**RESPONSE TO OHIO EPA'S COMMENTS SOUTH
PLUME REMOVAL ACTION EE/CA**

**DOE-FMPC, OEPA
18
REPORT
OU5**

RESPONSE TO OHIO EPA'S COMMENTS

SOUTH PLUME REMOVAL ACTION

FIGURE 1

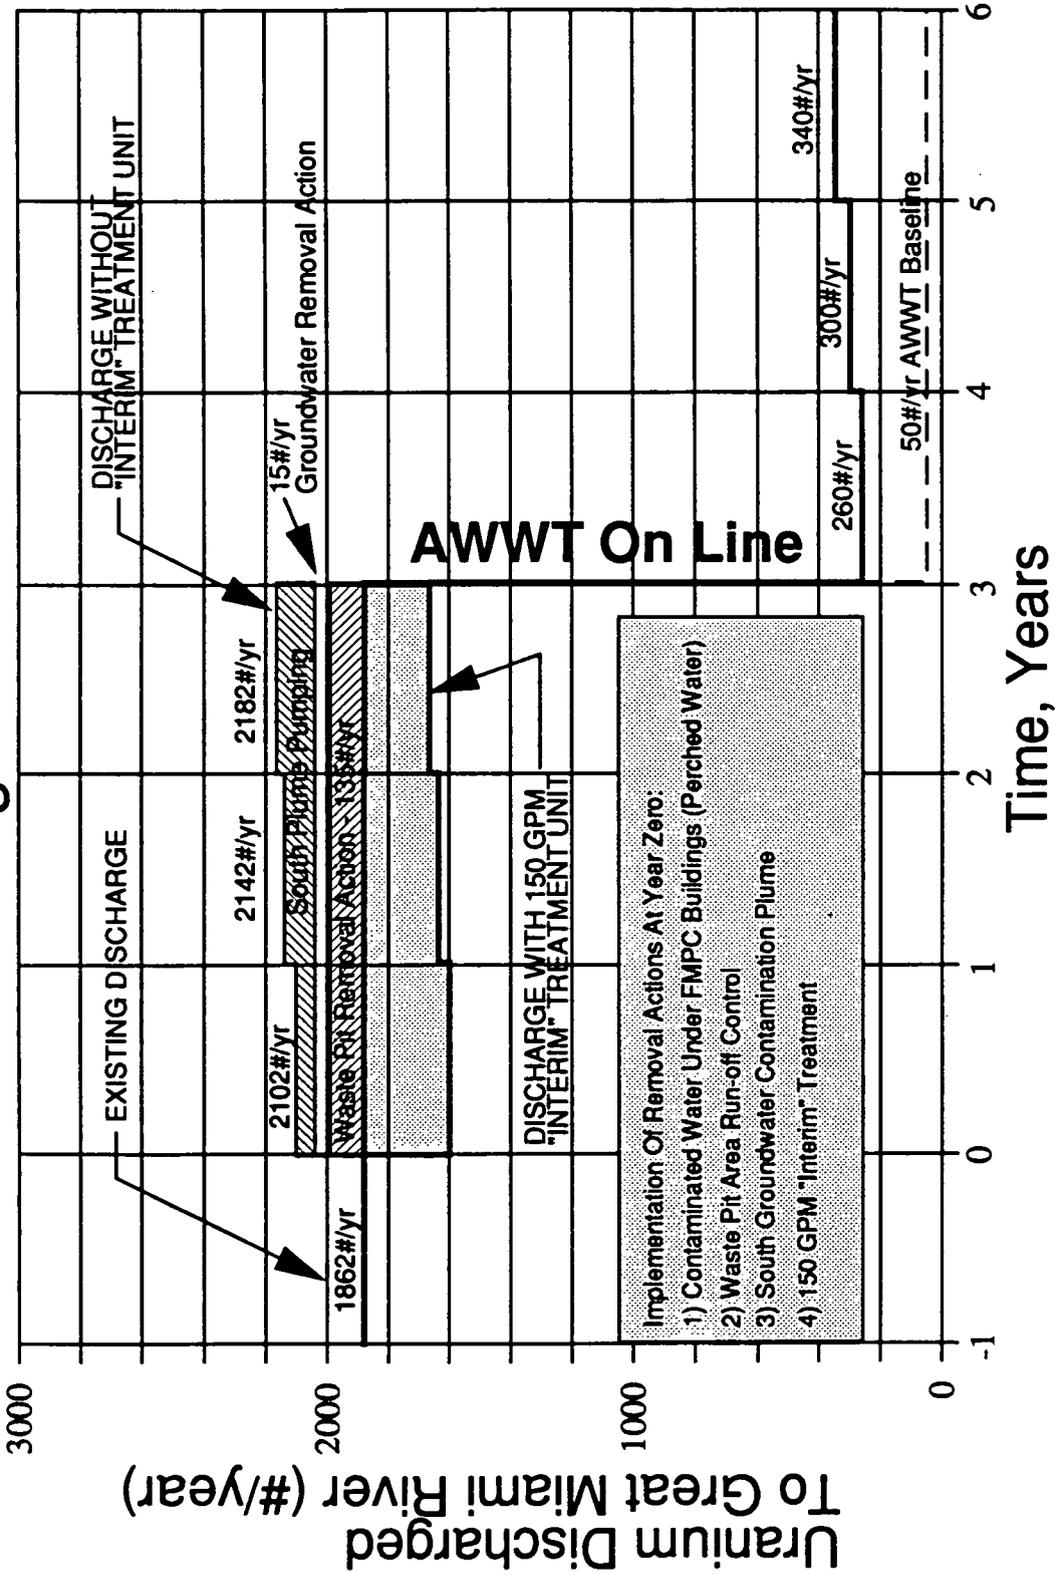
Page ES-13, Table ES-1, Aquatic Ecology: Although from an acute toxicity standpoint, Alternative 4 may have a marginal positive impact on the Great Miami River, in actuality the above background river water concentration of uranium will increase an additional 10%. This increase in uranium concentration in the river water will only increase any possible chronic effects on the aquatic community. The possibility for increased chronic effects from this alternative should be acknowledged in the text.

As stated in the EE/CA, the DOE is designing an Advanced Wastewater Treatment (AWWT) facility for the FMPC. The AWWT will treat existing FMPC wastewater discharges to remove radionuclides. The AWWT is projected to begin operation in December 1993. DOE has proposed to install a 150 gpm "Interim" Advanced Waste Water Treatment (IAWWT) unit as part of the South Groundwater Containment Plume Removal Action. This unit would remove uranium from a

portion of the FMPC wastewater currently being discharged to the Great Miami River (GMR). The IAWWT unit would operate until the AWWT becomes operational. The mass of uranium that will be removed from the FMPC waste water will exceed the amount that the various removal actions will be contributing to the GMR. Attached is a Figure 1 demonstrating this concept and how the implementation of the various removal actions & AWWT will occur. This figure quantifies the amounts of uranium that each removal action will contribute to the GMR and how the 150 gpm unit will remove a greater amount of uranium from the process waste water that is discharged to the GMR. This figure clearly demonstrates that the addition of the 150 gpm unit would prevent any increased risk to human health and/or the environment.

Alternative 4 of the EE/CA is being revised to include the 150 gpm "Interim" Advanced Waste Water Treatment unit. All sections of the EE/CA which evaluate Alternative #4 will be changed accordingly.
